Access Compliance Report

Public Rights-of-Way

(Curb Ramps)

Intersection ID: 52550	Main Street: MEADOW_BOTTOM_RD	Cross Street: KRISTENS_MARE_DR	Location: W
ADA ID: A03179C2EA4C	Ramp Type: PerpDiag	Initial Pass/Fail: Fail	Overall Compliance: No
Severity Score: 13.75			
Codes/Mitigation Info/Possible Solution		Field Measurements/Component Compliance

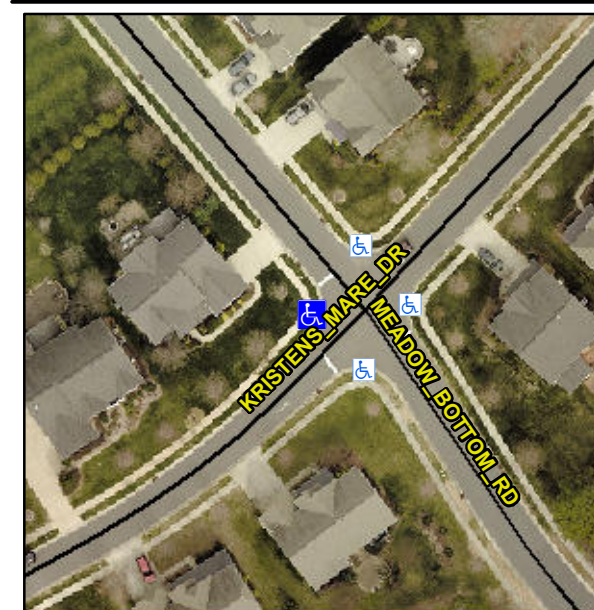
Not Found, R304.2.2, R304.5.3

Compliance	Description	Data	Compliance	Description	Data
N/A	Ramp Length (in)	48.0	No	Ramp Slope (%)	8.8
Yes	Ramp Width (in)	48.0	No	Ramp XSlope (%)	4.8
N/A	Flare Type LT	N/A	N/A	Flare Type RT	N/A
N/A	Flare Slope LT (%)	N/A	N/A	Flare Slope RT (%)	N/A
N/A	Flare Traversable LT?	N/A	N/A	Flare Traversable RT?	N/A
N/A	Landing Length (in)	N/A	N/A	DWS Provided?	N/A
N/A	Landing Width (in)	N/A	N/A	DWS Contrast?	N/A
N/A	Landing Slope (%)	N/A	N/A	DWS Length (in)	N/A
N/A	Landing X Slope (%)	N/A	N/A	DWS Full Width?	N/A
N/A	Landing Curb? (Y/N)	N/A	N/A	DWS Offset (in)	N/A
N/A	Shared Landing?	N/A			
N/A	Gutter Ponding?	N/A	N/A	Gutter Slope (%)	N/A
N/A	Gutter Lip Ht (in)	N/A	N/A	Gutter X Slope (%)	N/A
N/A	Painted X Walk1?	No	N/A	Painted X Walk2?	No
	X Walk 1 Direction	To SE		X Walk 2 Direction	To NE
N/A	X Walk 1 Width (in)	N/A	N/A	X Walk 2 Width (in)	N/A
	X Walk 1 Slope (%)	0.7		X Walk 2 Slope (%)	2.3
	X Walk 1 X Slope (%)	3.7		X Walk 2 X Slope (%)	0.3

Remove & Replace Curb Ramp With Two New Directional Ramps or Equivalent.
